Kirby Morgan Dive Systems, Inc.®

Bulletin #7 of 2011. October 04, 2011

Change To Product Bulletin

REX® Regulator Exhaust Valve Part Number 510-777

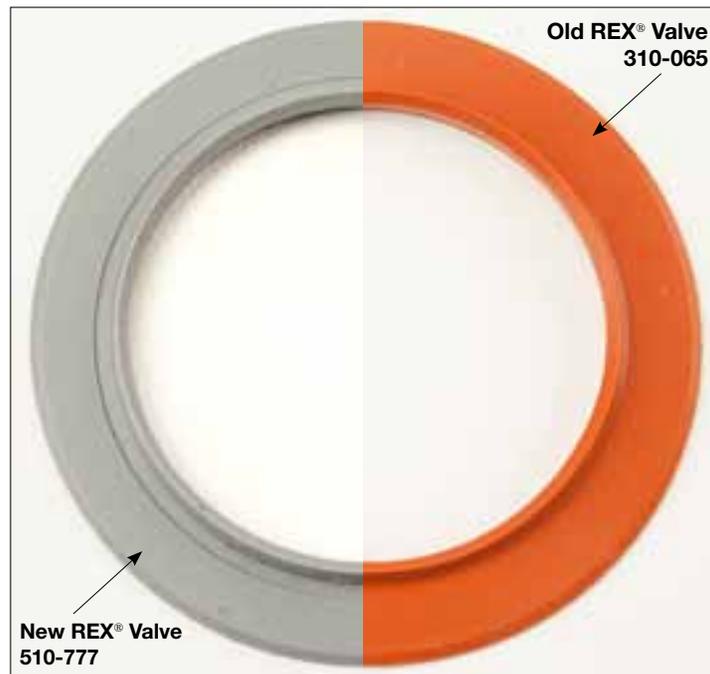
Under certain conditions, the original regulator main exhaust valve, 310-065, used in the REX® regulator assembly, 505-278 could be susceptible to low exhaust flow oscillations, or “Honking”. Several variables have been found to cause this. A solution to this issue has been found by making a slight modification to the shape of the valves. The new part number is 510-777 and the parts are easily distinguished by the change in color from orange/red to medium GRAY. No change to associated procedures for maintenance of the valve are necessary.

*Note: This valve is **not** for use on the EXO® 26 or EXO® BR Full Face Masks. The EXO® Masks will continue to use 310-065 exhaust valve.*
